ATTACHMENT A

KENWOOD COMMUNITY & SENIOR CENTER ATTACHEMENT A

ADDENDUM #1 – REVISED DRAWINGS

Beaty Palmer Architects, Inc. all rights reserved.
no part of this document may be reproduced or utilized in any form
without prior written authorization of beaty palmer architects, inc.
S3.8
BEATY PALMER ARCHITECTS

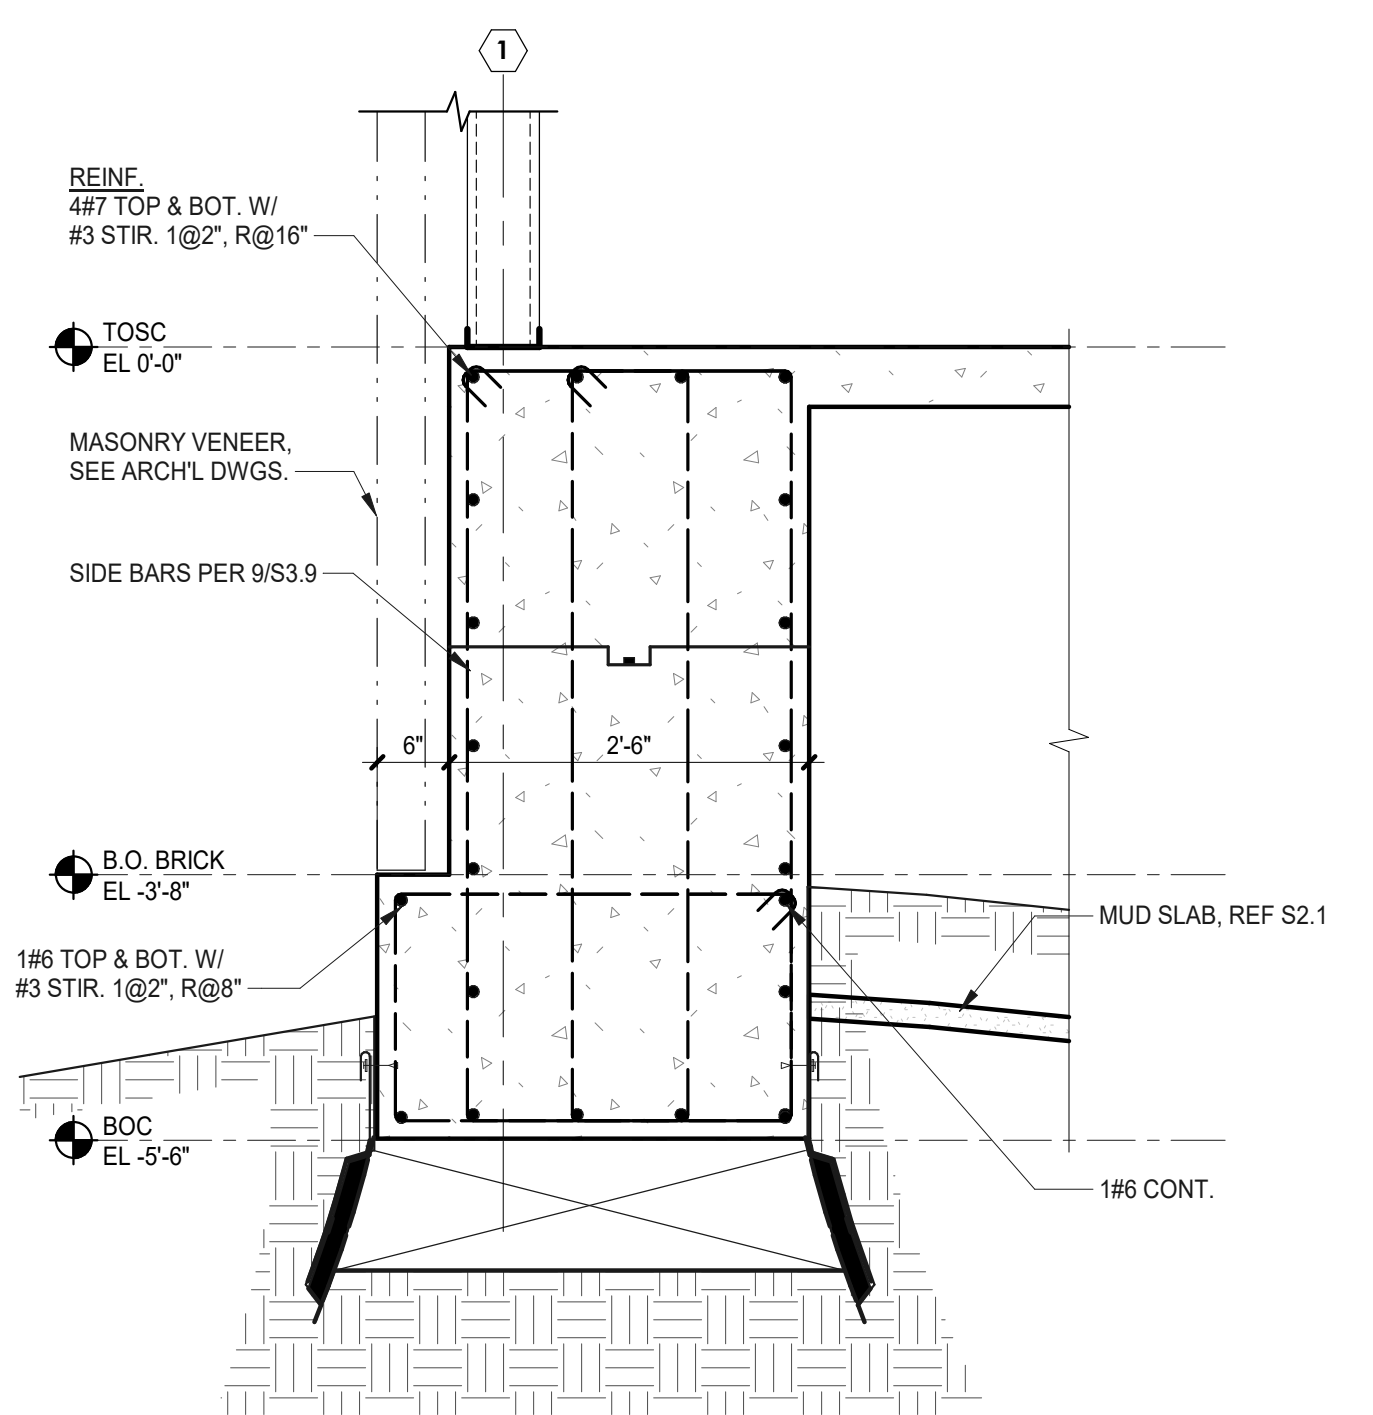
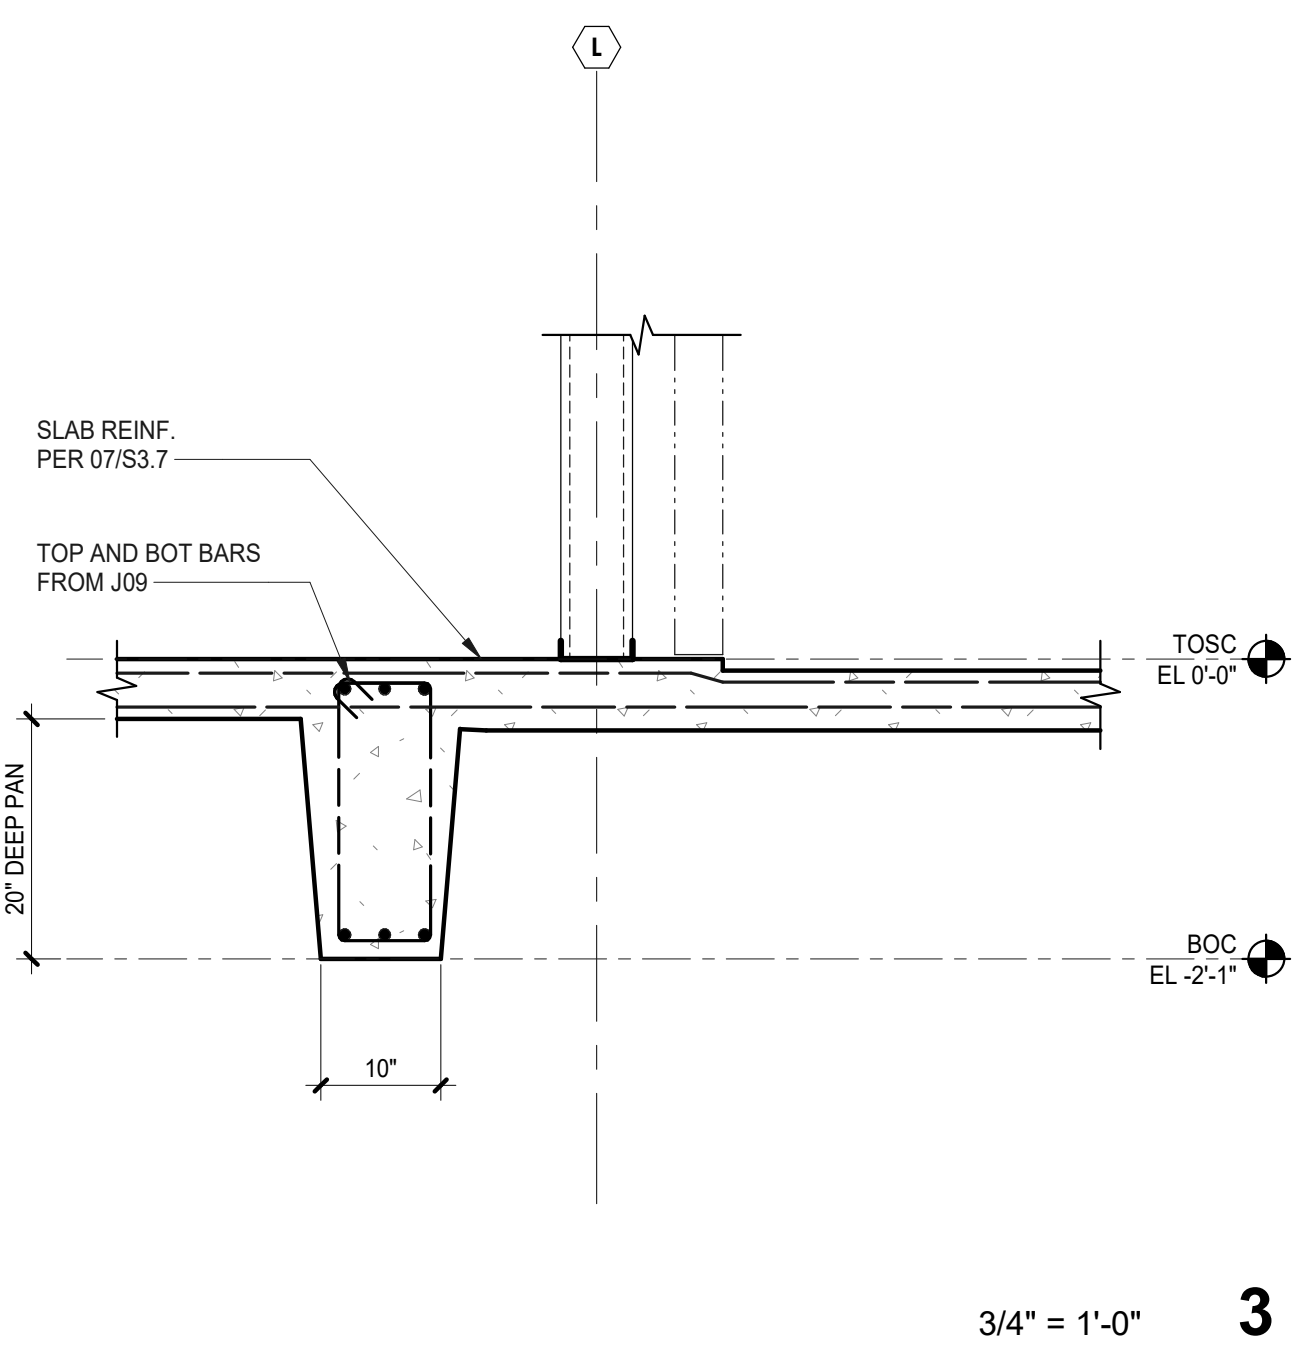
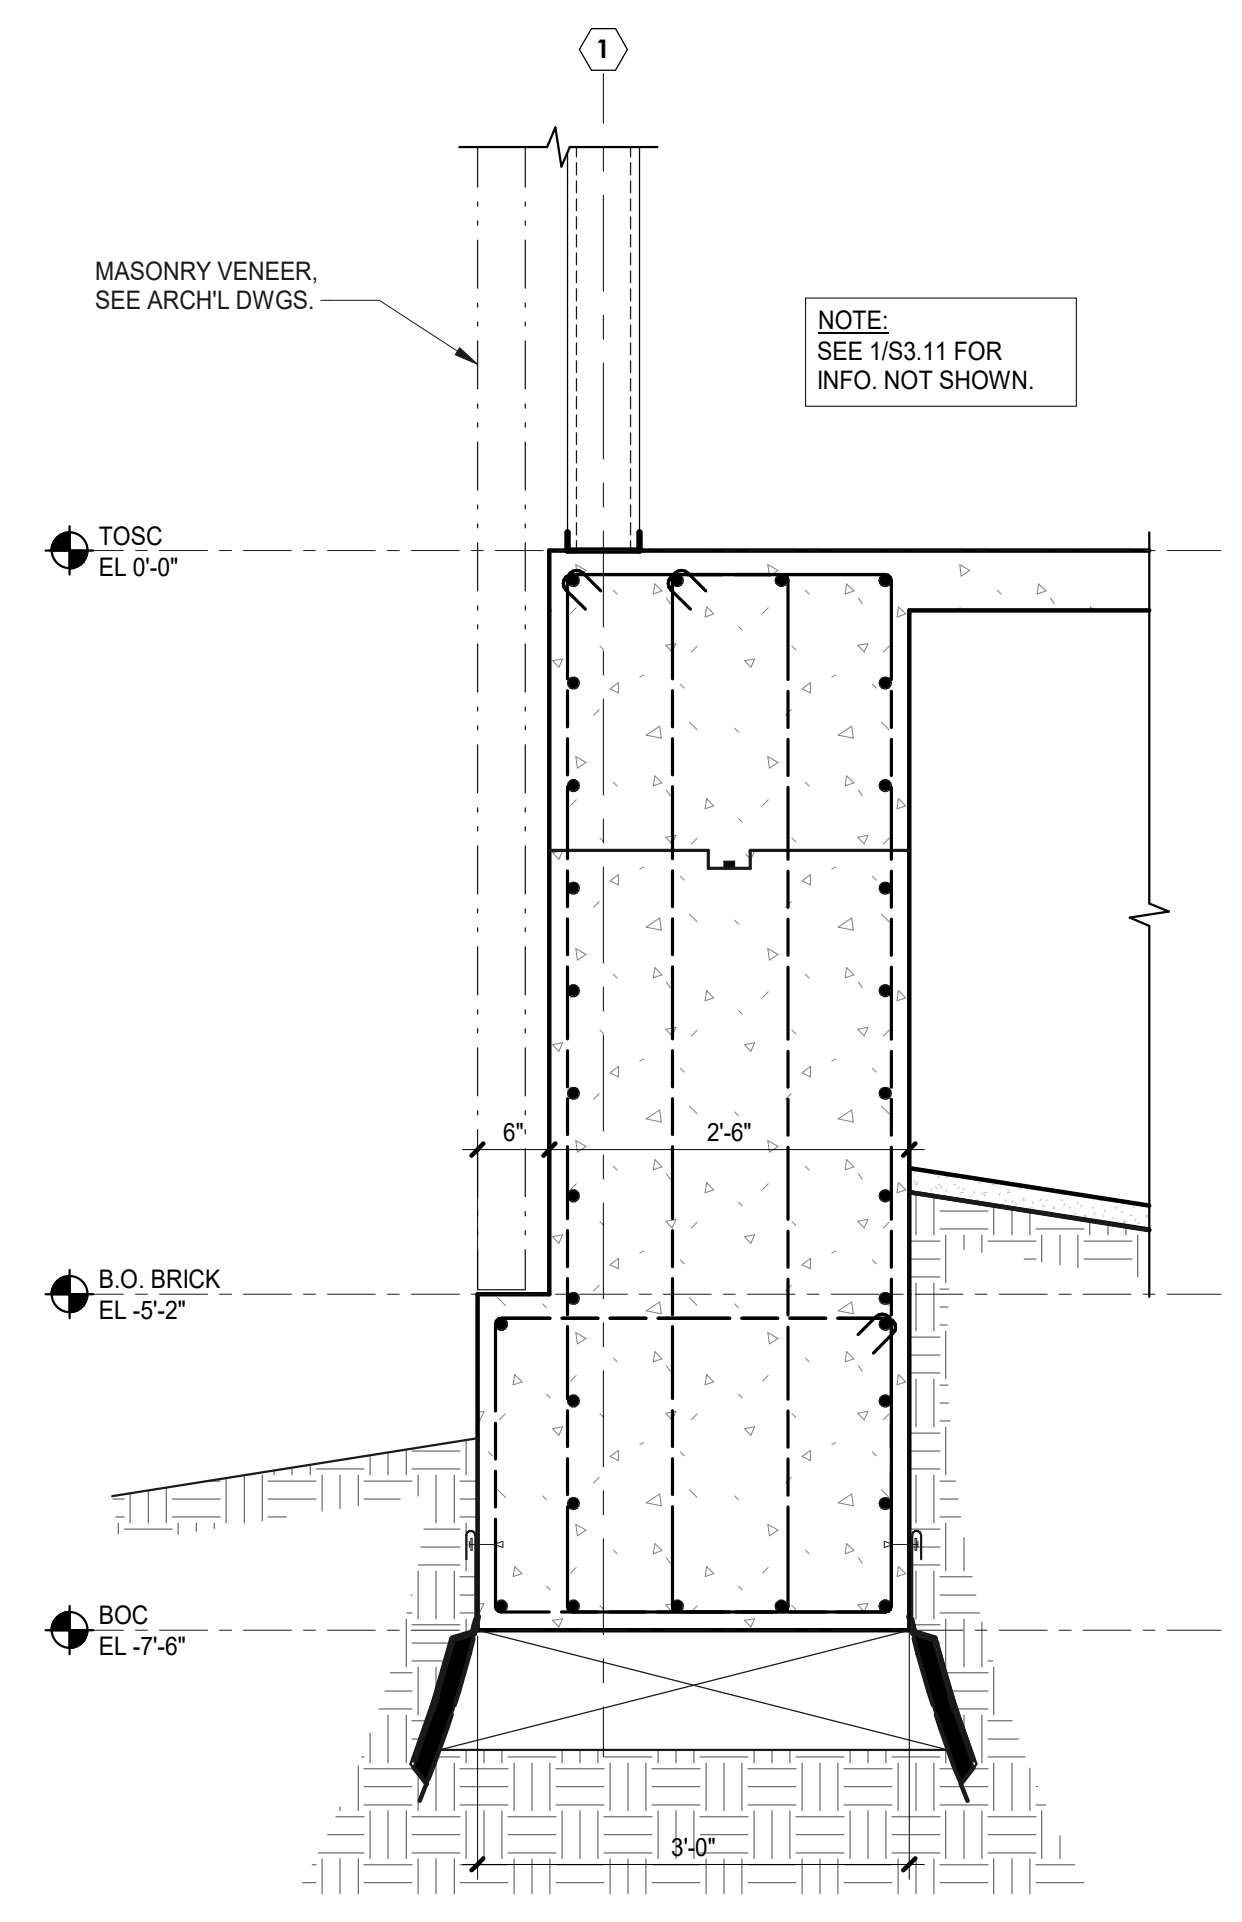
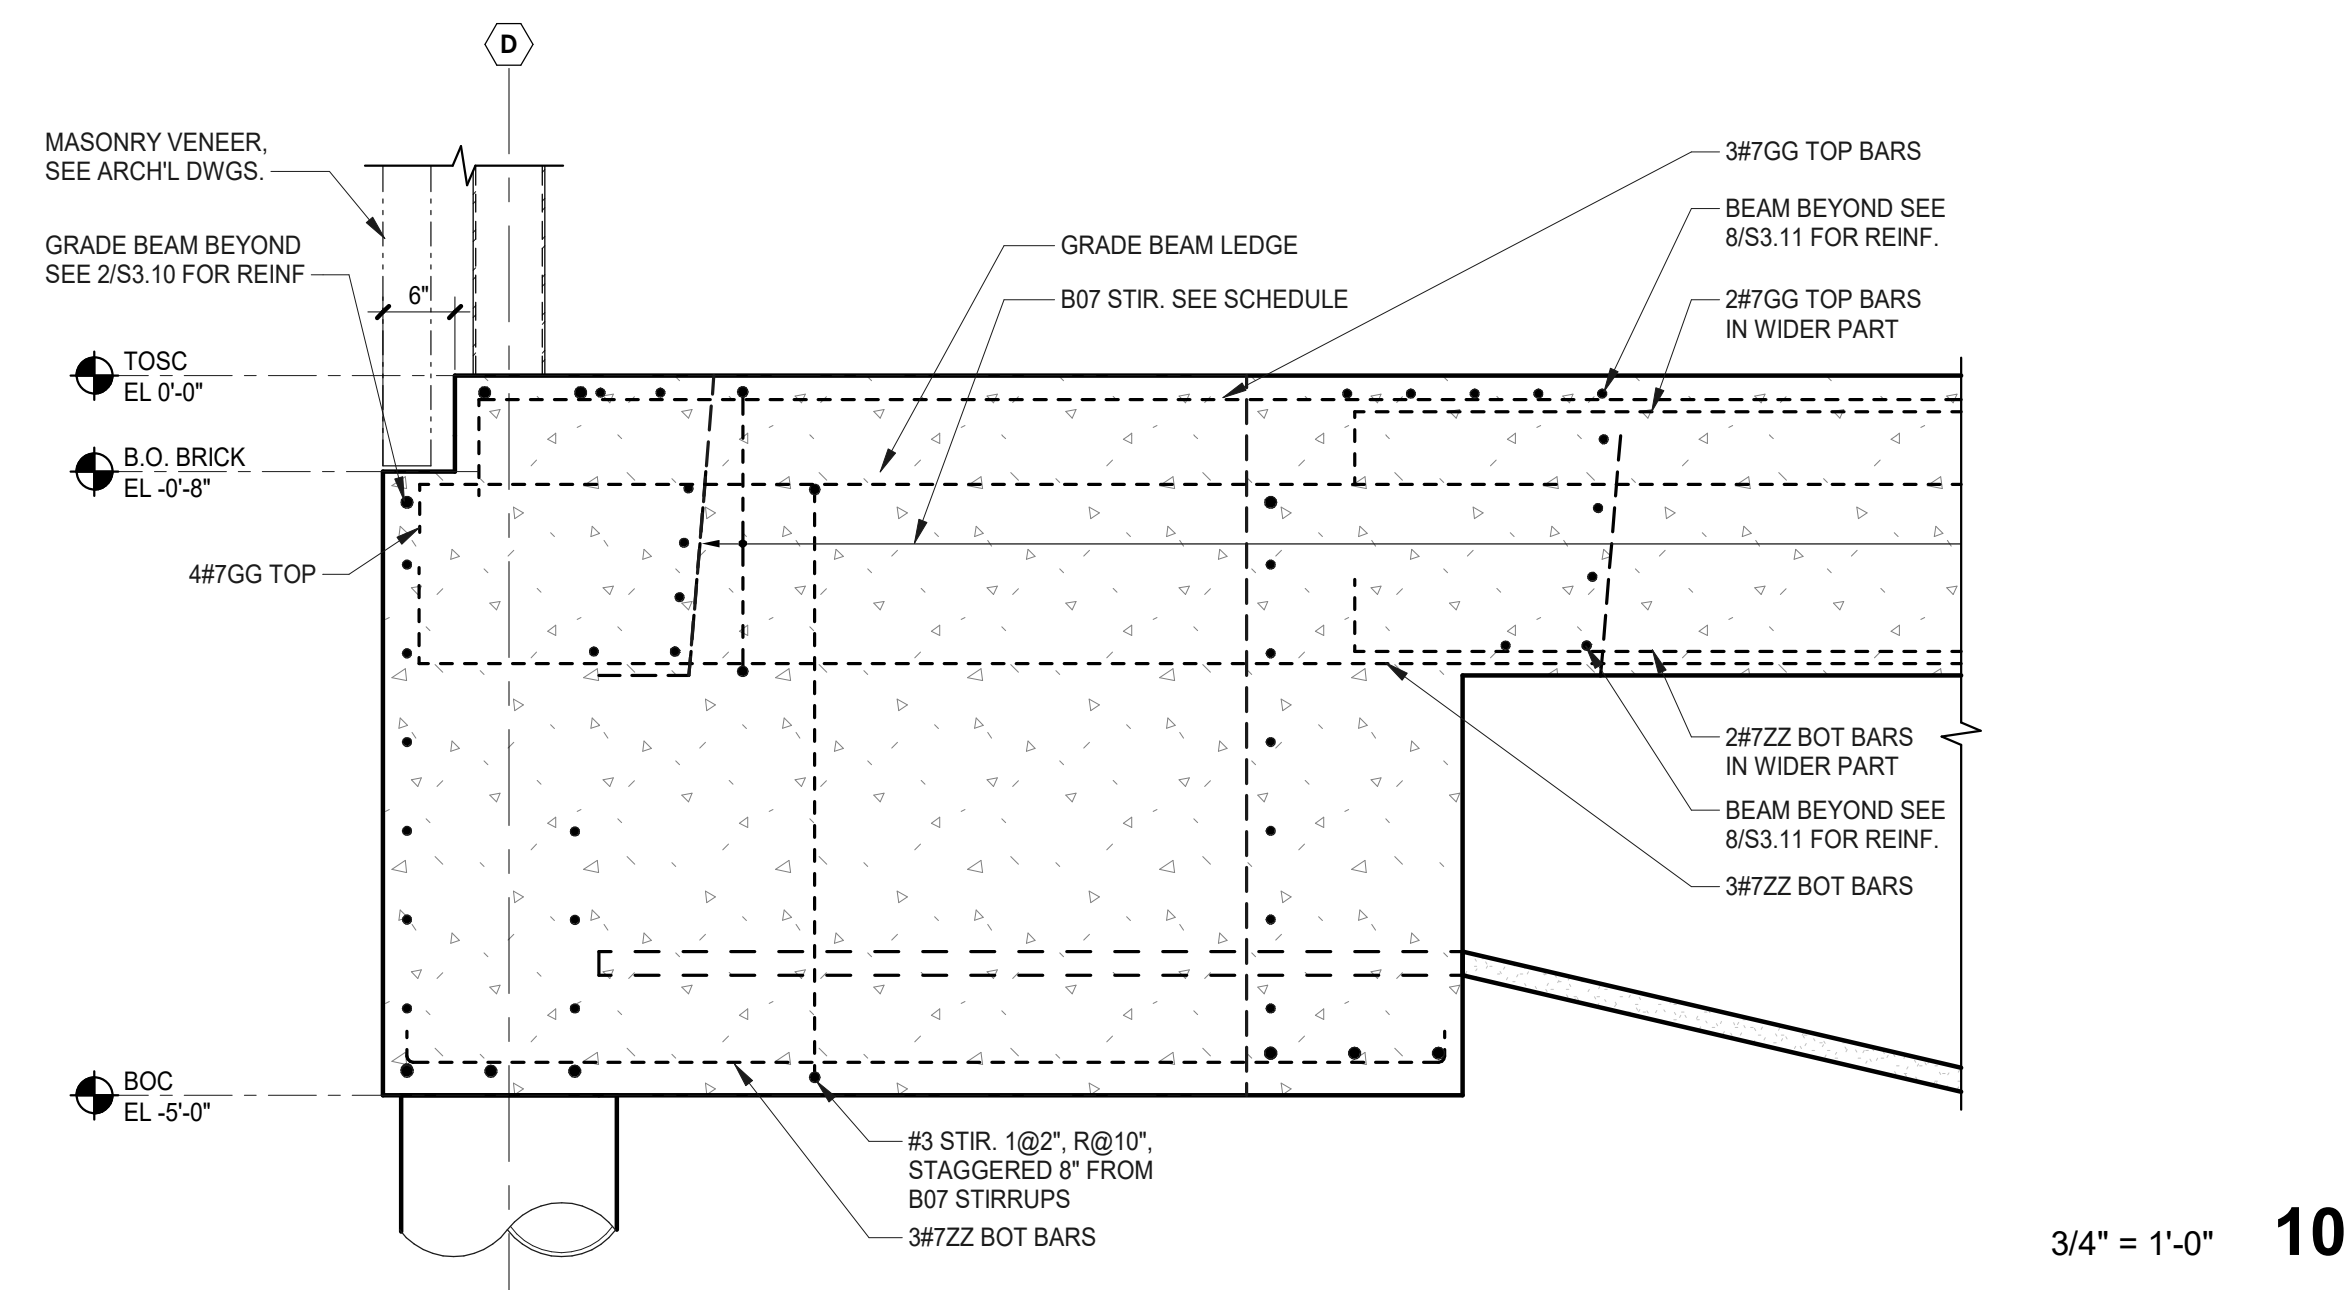
A requirement has been added to ensure the pan removal hatch is not located within polished concrete areas, refer to attached revised sheet S3.8.
